Docket Item # 13 & 14  
BAR CASE # 2015-0189 & 190

**ISSUE:** Buildings 1 and 2  
**APPLICANT:** RTS Associates, LLC  
**LOCATION:** 2 Duke Street  
**ZONE:** W-1 / Waterfront

**BAR 2015-0189 and 0190: 2 Duke Street/Robinson Landing**

**Note:** This is the second review of Certificates of Appropriateness for Buildings 1 and 2. Staff has coupled the reports for Building 1 (#2015-0189) and Building 2 (#2015-0190) due to the interrelatedness of these two waterfront buildings.

# BUILDING 01 OVERALL ELEVATIONS

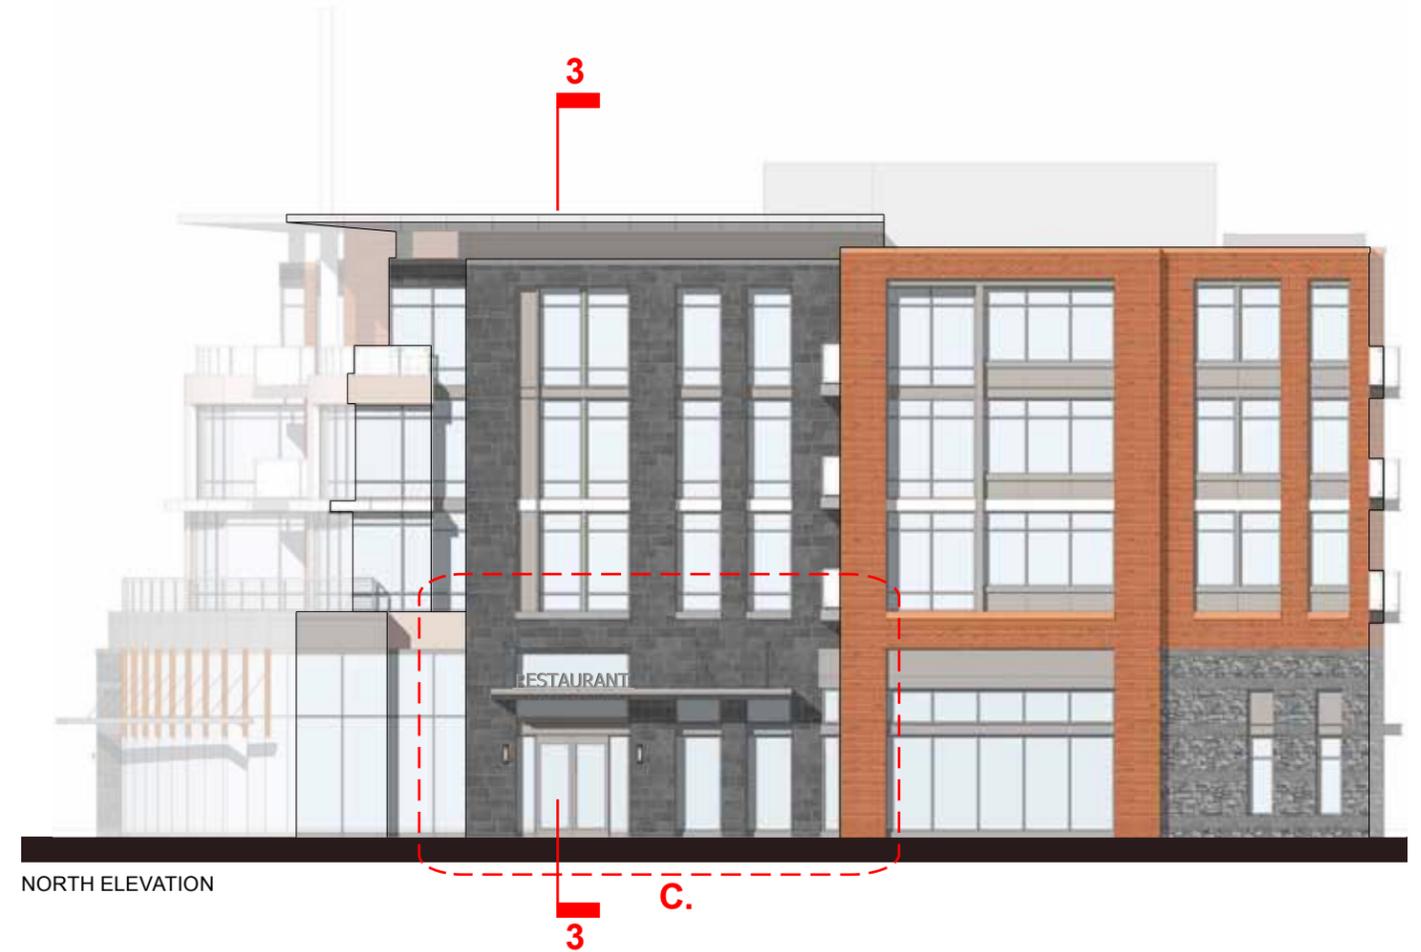
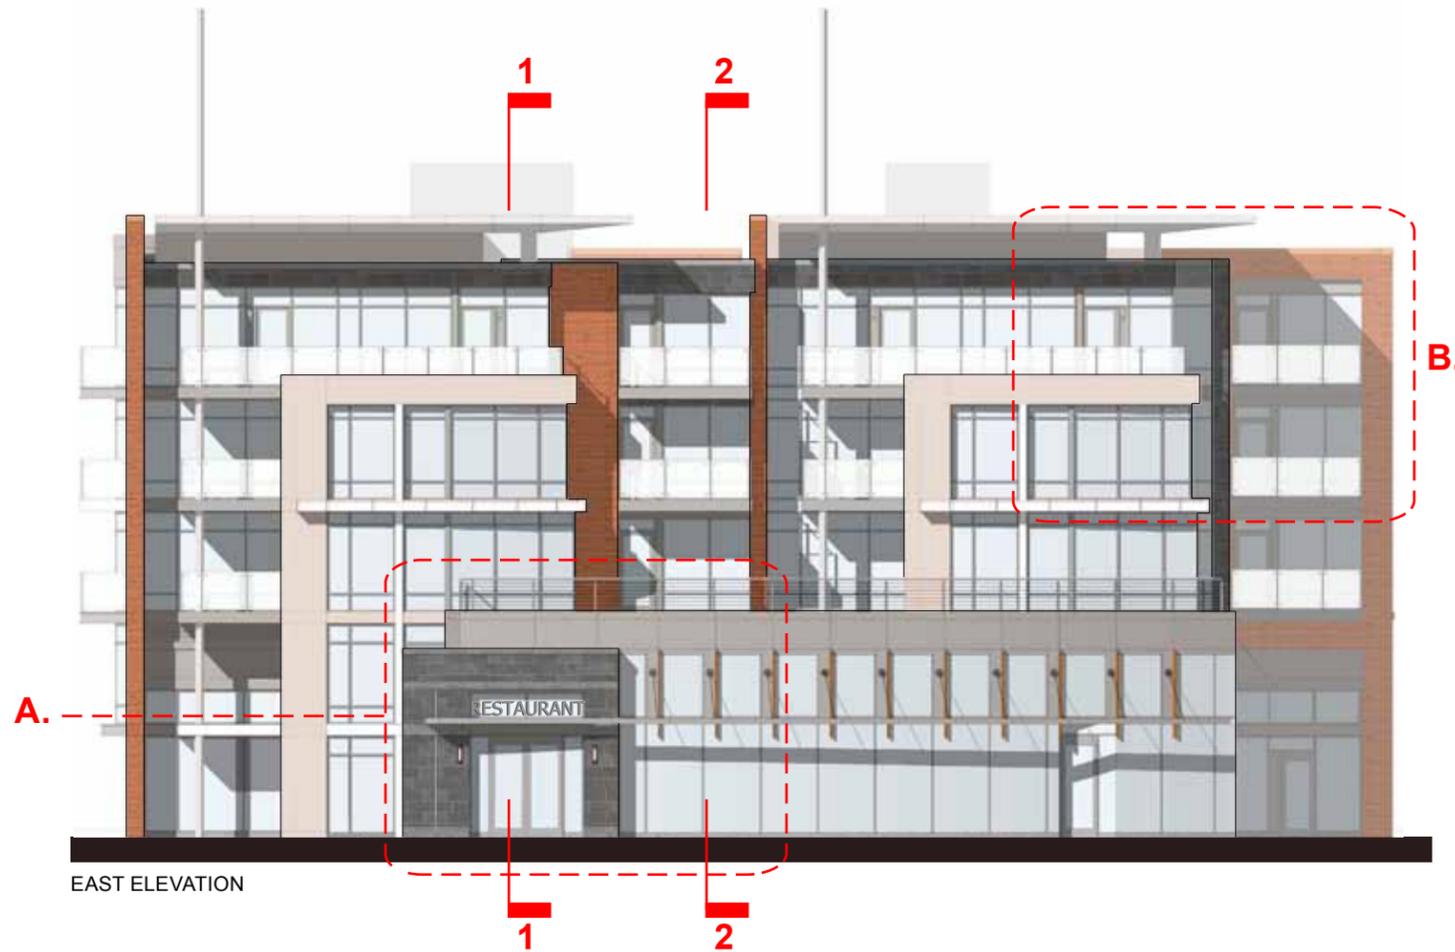
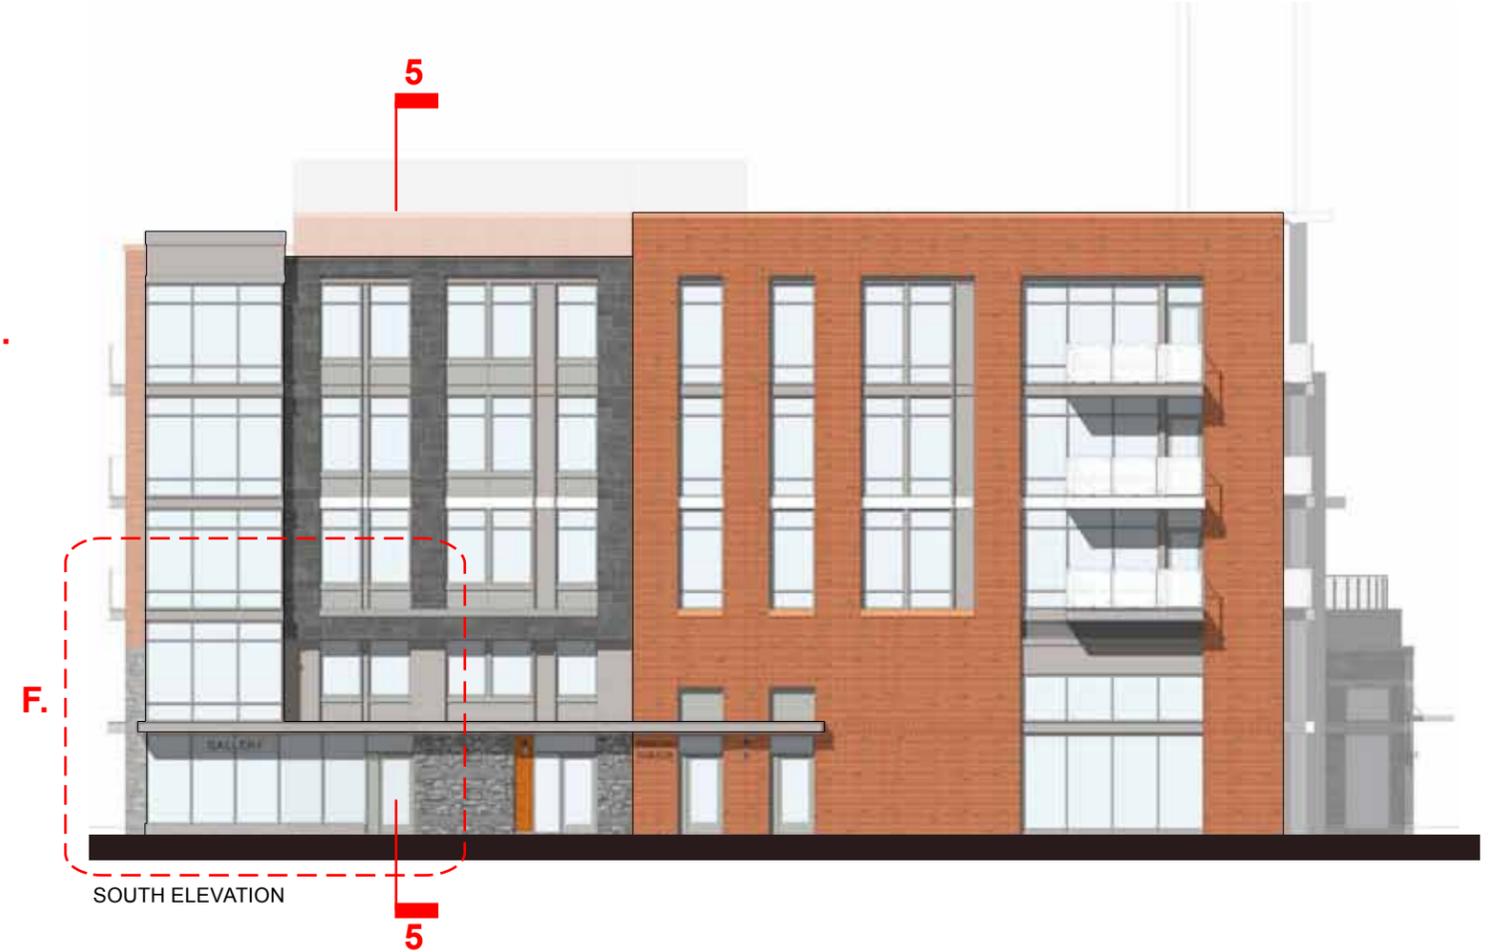
These two comments have been addressed and can be seen in a detail of the west elevation of Building 1 as shown in Figure 4. The current scheme shows the elimination of the gap that previously had a shadow line and a steel beam. The rough stone, which will be subject to final approval on the materials board and a mock-up on the field, has been proposed with bands of thermal-finished stone. Staff finds this a successful way to incorporate a historically sourced material in a balanced way. Staff will work with the applicant to confirm that the rough stone will have a mix of tan/beige and grey stone, similar to the color composition of the exposed foundation at Fitzgerald’s Warehouse.

The applicant has increased the use of red brick and softened the dark charcoal grey in several instances. The north elevation of Building 1 now carries down brick to the ground floor in one portion where there had previously been the stone foundation. Both the north and south elevations of Building 2 now feature more red brick. The waterfront elevation of Building 2 also includes red brick at the ground floor in some locations and in some of the recessed elements.

# BUILDING 02 OVERALL ELEVATIONS

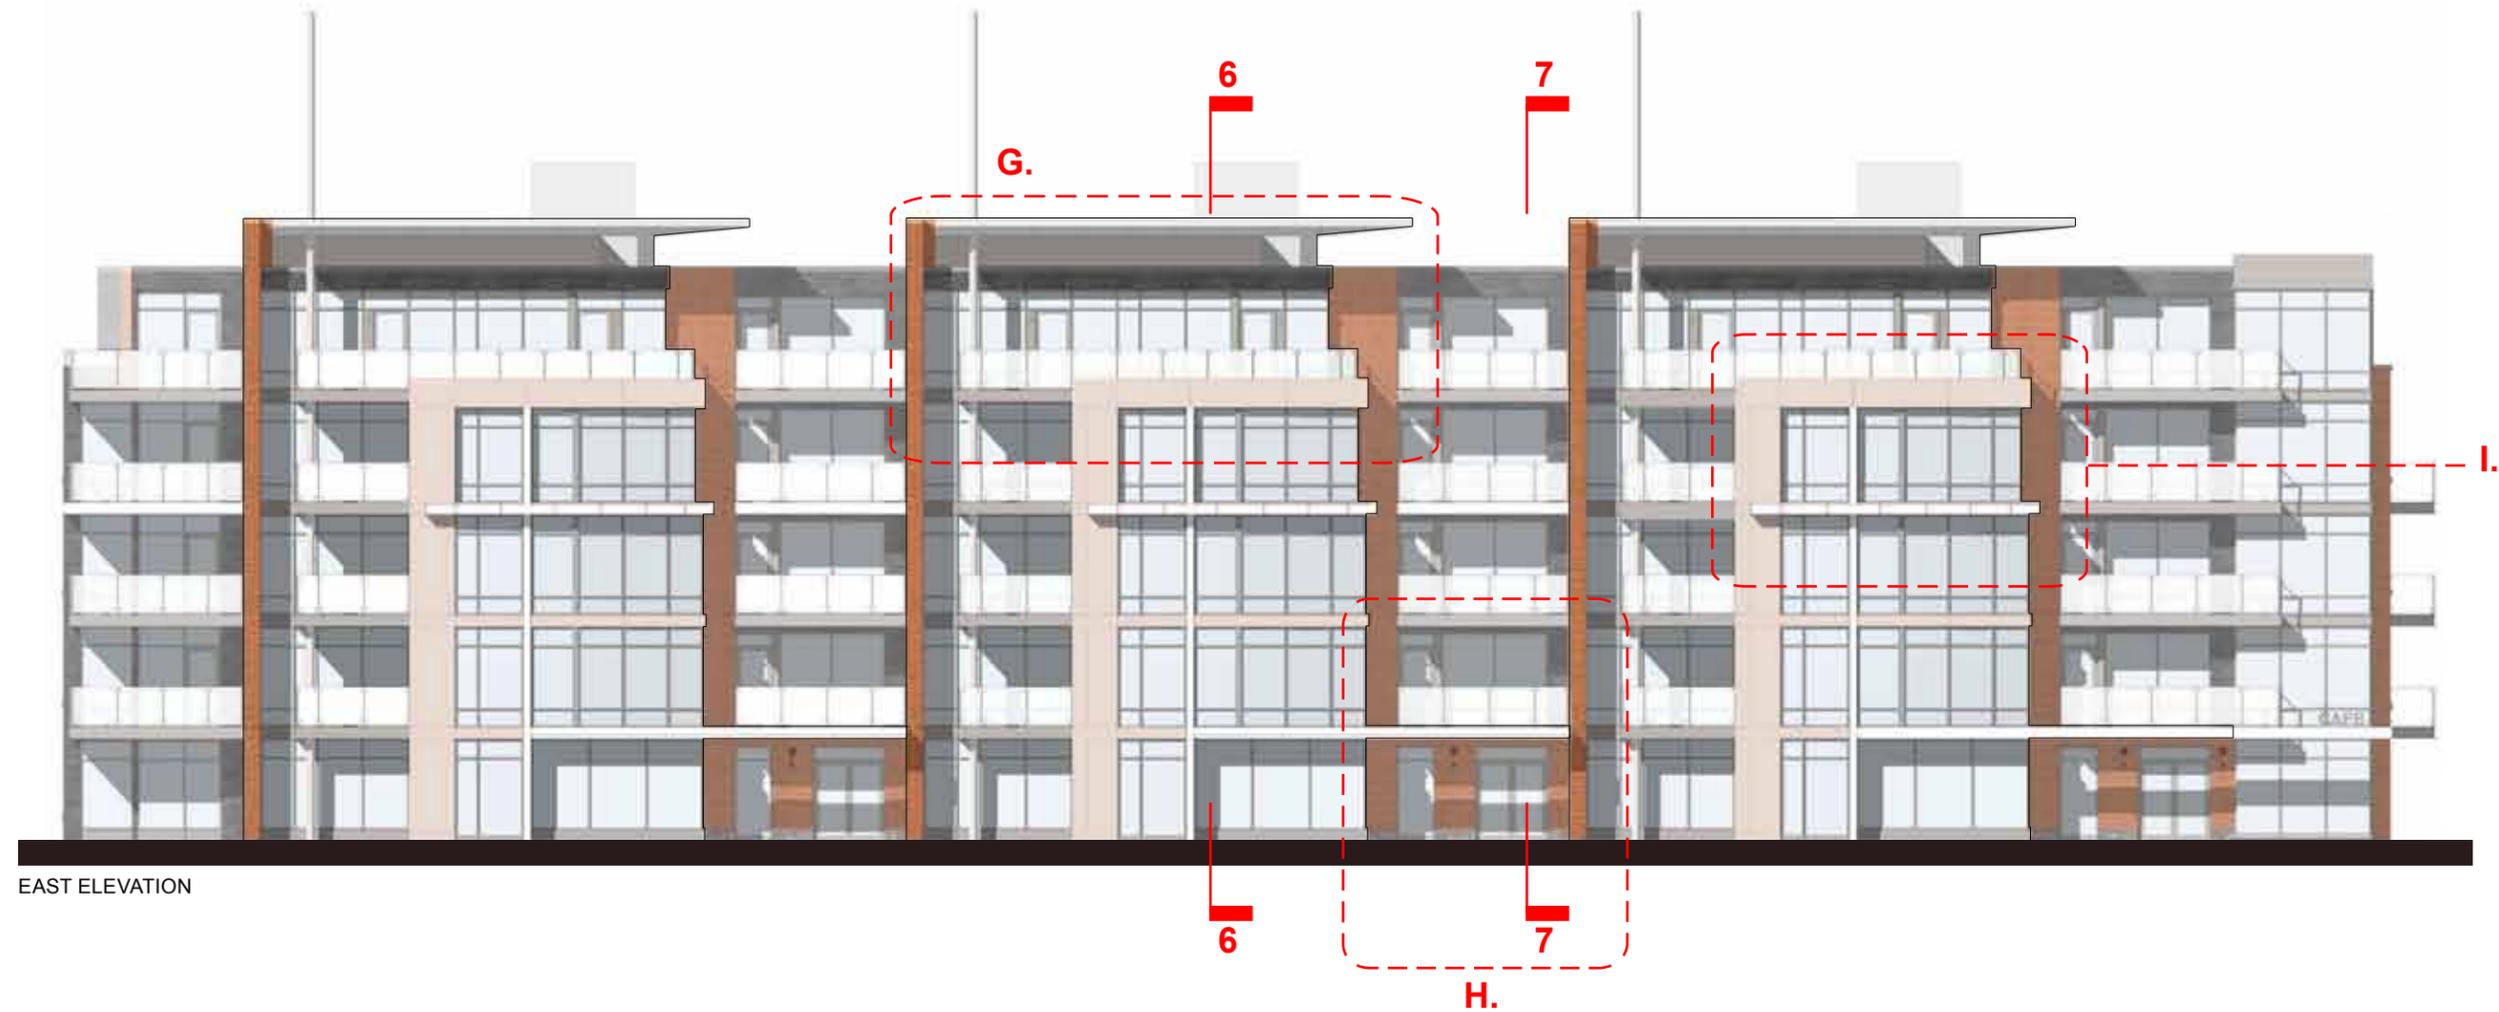
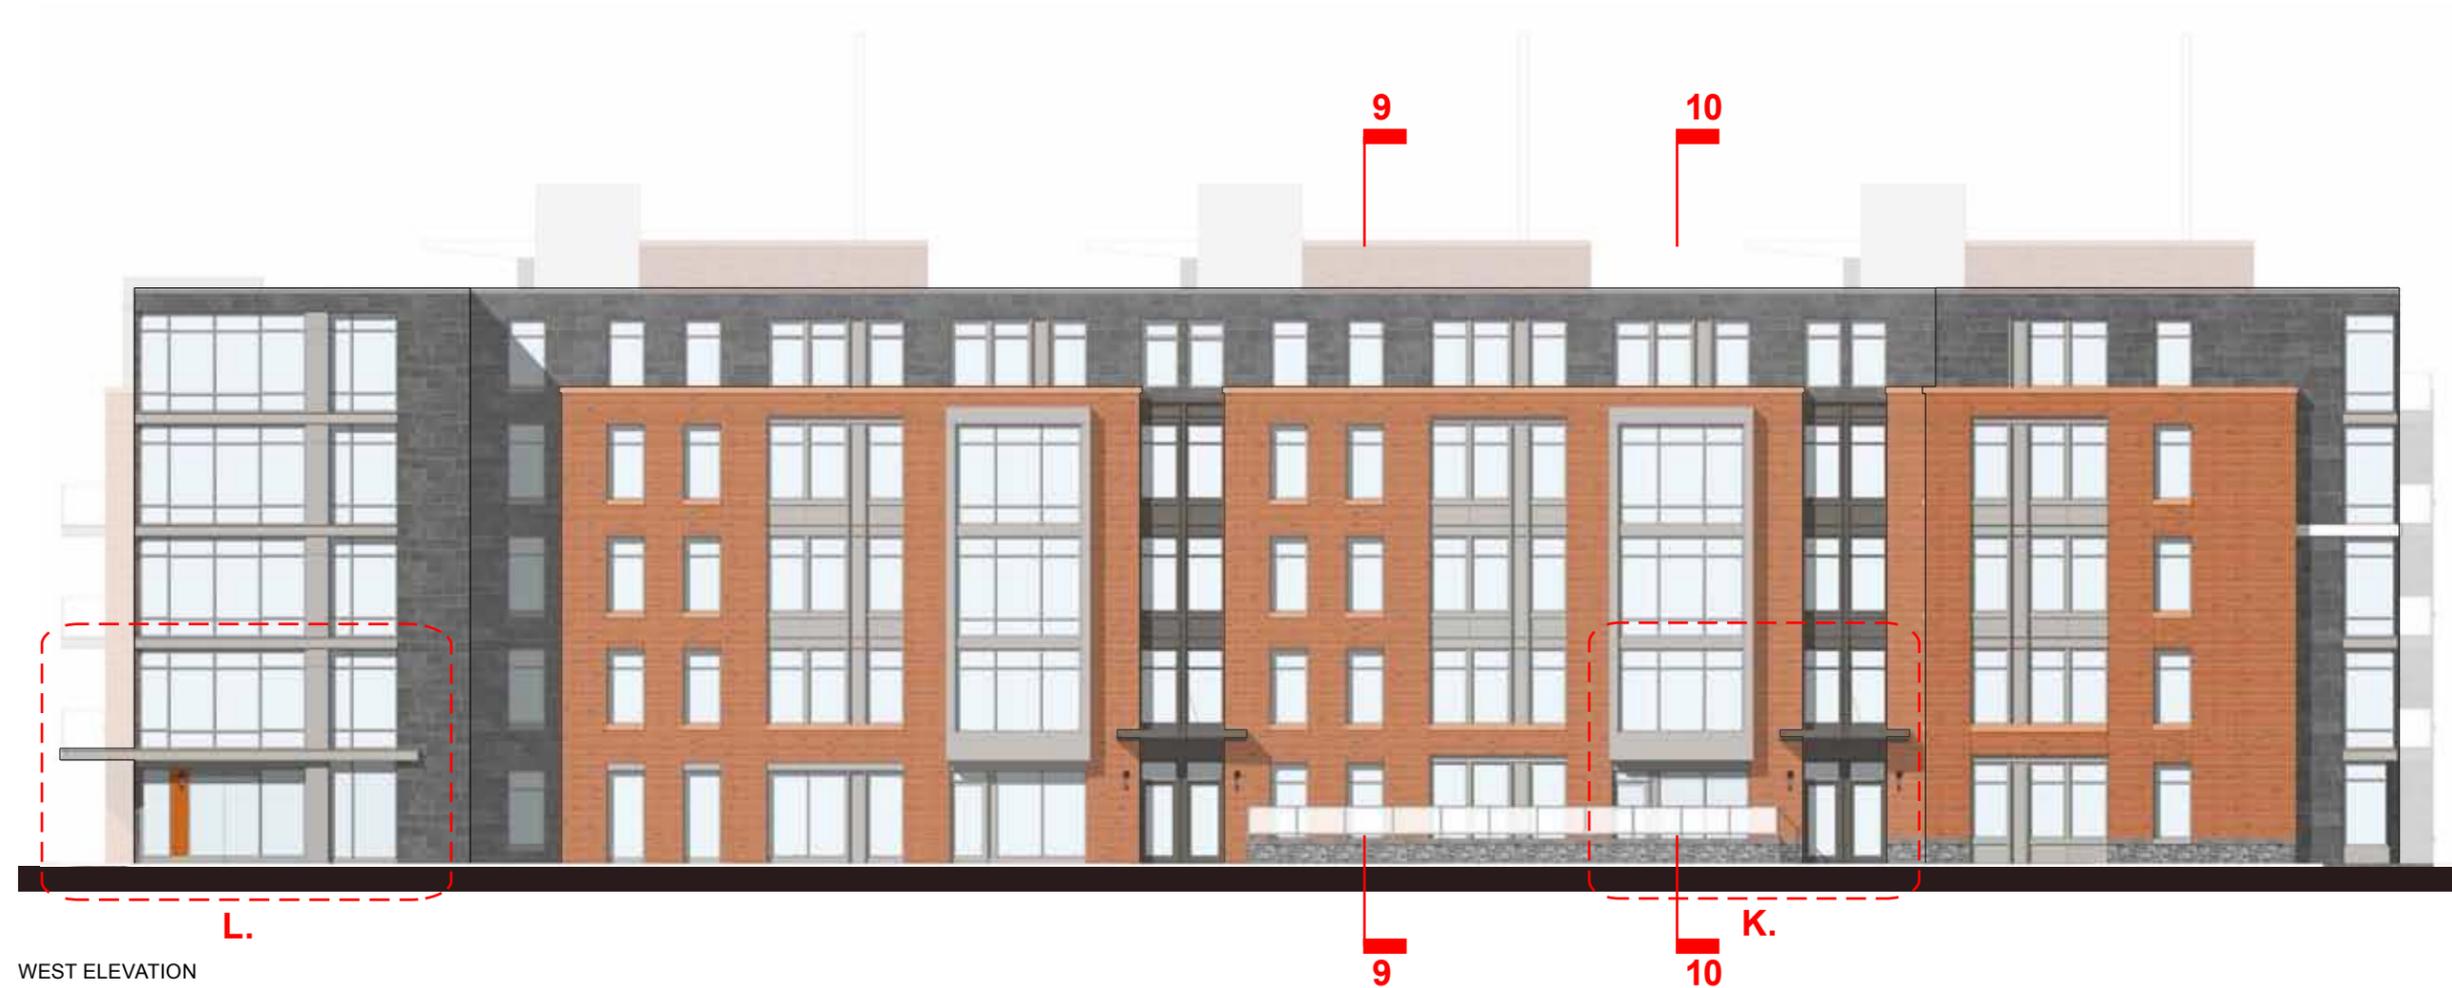
Previously, some had expressed concerns that the west elevations felt too flat and that the bays, shadows and reveals were not substantive, resulting in some bays or brick portions feeling “applied” rather than integrated. The plan of Building 2 on Sheet 27 provides evidence of the strong projections proposed on all four elevations. The elevations also reflect this increased variation and set back, particularly on the west elevation, where three-story bays have been added and there is an increase in some of the reveals and setbacks.
